PR/1144/21

Record of Executive Business and Chief Executive's Order

Reg. Reference: SD21A/0181 **Application Date:** 01-Jul-2021

Proposed Development: Alterations to previous approved planning application, Reg. Ref. SD15A/0105, consisting of: construction of a new single storey flat roof modular changing facilities (293sq.m) ancillary to the existing playing pitch; relocation of approved 38 carparking spaces and 2 coach parking bays from northern boundary to the eastern boundary adjacent to Cloverhill Road installation of new overhead flood lights; 3 new flag poles; continuation of previously permitted boundary wall and footpath (Reg. Ref. SD15A/010) extending along the south eastern boundary, with addition of new security fencing added to top of wall, all adjacent to Cloverhill Road; new entrance gates (accessed via the permitted entrance off Cloverhill Road); all associated boundary treatment, landscaping and ancillary works necessary to facilitate the development.

Red Line

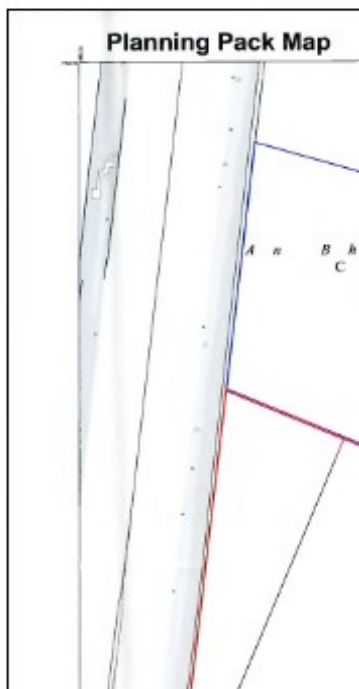
The proposed application alters the proposed red line quite significantly:

It is apparent that the red line for the current application excludes areas which it is seeking to change. It also includes additional areas within the redline which were not previously included. The applicant is therefore requested to submit a revised site location plan. For clarity, this should cover the extent of the redline under SD15A/0105, as well as any additional areas. As there are amendments to the redline this would be **significant additional information**. Revised newspaper and site notices should therefore be provided. In addition to this, it is noted that the notices do not currently set out that the current application is proposing to change the red line from that which was previously granted. The revised notices should address this matter.

1. The applicant is requested to submit a revised site location plan indicating the following within the redline:
 - extent of SD15A/0105
 - additional areas proposed as part of this developmentThese changes are considered significant and revised newspaper/ site notices are required.
